PLANNING APPROVAL STAFF REPORT**Date: June 1, 2006****NAME**

AREA OF PROPERTY40,338 \pm square feet / 0.9 \pm acres**CONTEMPLATED USE**Planning Approval to allow a swimming club in an R-1,
Single-Family Residential district**TIME SCHEDULE
FOR DEVELOPMENT**

APPLICATION NUMBER 21 DATE June 1, 2006

SITE PLAN

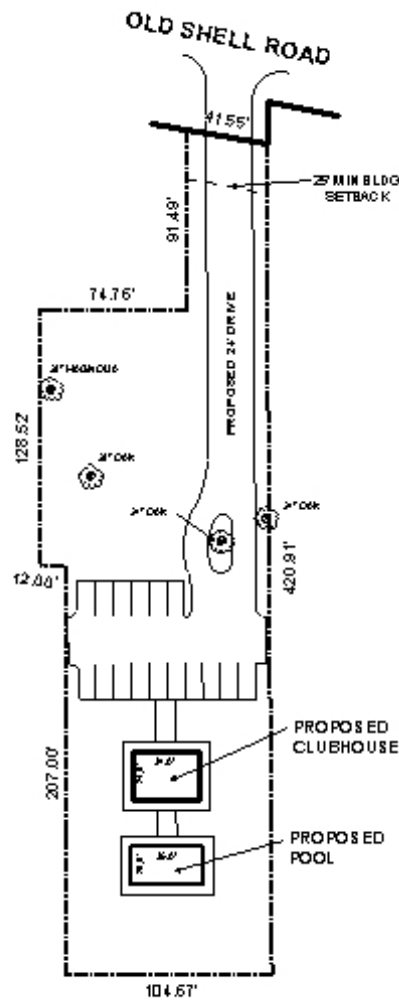
The site plan shows that a 16 space parking area will be located approximately 225 feet South of Old Shell Road, and will be connected to Old Shell via a 24-foot wide drive. South of the parking area is the proposed 816 square foot clubhouse, and the 20 by 36 foot pool. The southernmost portion of the paved area around the pool is approximately 40 feet from the rear property line, and approximately 28 to 30 feet from the East and West property lines.

The site slopes from Old Shell Road East and South towards the residences located within the Cobblestone subdivision. As the development of the site will increase surface parking and other impervious surface areas on the site, full compliance with the City's Stormwater Ordinance may be necessary. If compliance with the Stormwater Ordinance requires the provision of a detention pond, the pond should be depicted on the site plan.

Because the site abuts residential uses to the East, South and West, a protection buffer in conformance with Section 64-4.D. is required. The required protection buffer may be a 10-foot wide planting strip or a six (6) feet high privacy fence (except for the portion of the fence within the 25-foot setback line, which can only be 3-feet tall). The site plan should be revised to depict the required protection buffer.

As the applicant is proposing to utilize the site for private parties, some sort of private garbage removal service will be required. There currently is no indication on the site plan regarding the proposed location of any dumpster or other waste storage facility. If the applicant utilizes a dumpster, the location of the storage area for the dumpster must be indicated on the site plan, and

Pools require periodic chemical treatment, and usually have a pump and filter system. If a separate storage structure will be provided for the storage of chemicals, and/or for the pump and filter system, it should be depicted on the site plan.

All residential pools built within the City are required to have a fence around the pool with a self-closing and latching gate. The fence is required because pools represent an “attractive nuisance” – they tend to attract children and thus may be a safety hazard if a child enters the pool without adult supervision. The site plan should be revised to reflect the location of any required safety-related fencing.

Finally, while not required by the Zoning Ordinance, handicap accessible parking spaces may be required by other regulations; therefore they should be depicted on the site plan. A wheelchair accessible route from the parking area to the clubhouse and pool may also be required.

Planning Approval: based on the preceding, it is recommended that the application be Heldover until the July 6th meeting so that the following can be submitted by June 14th: 1) information regarding how the proposed swim club will operate under the membership-based parameters of the Zoning Ordinance; 2) operating schedule and rules of operation regarding noise; 3) revision of the site plan to depict on-site lighting, and the provision of any associated information regarding the lighting fixtures; 4) revision of the site plan to show any required on-site detention facilities; 5) statement regarding the selected method for draining the pool; 6) revision of the site plan to depict the necessary residential adjacency buffers; 7) revision of the site plan to depict any dumpster facilities; 8) depiction of any additional structures proposed for chemical storage or pump/filter location; 9) depiction of the required safety-fence; and 10) depiction of any required handicap accessible parking facilities and additional sidewalks necessary to provide handicap circulation on site.
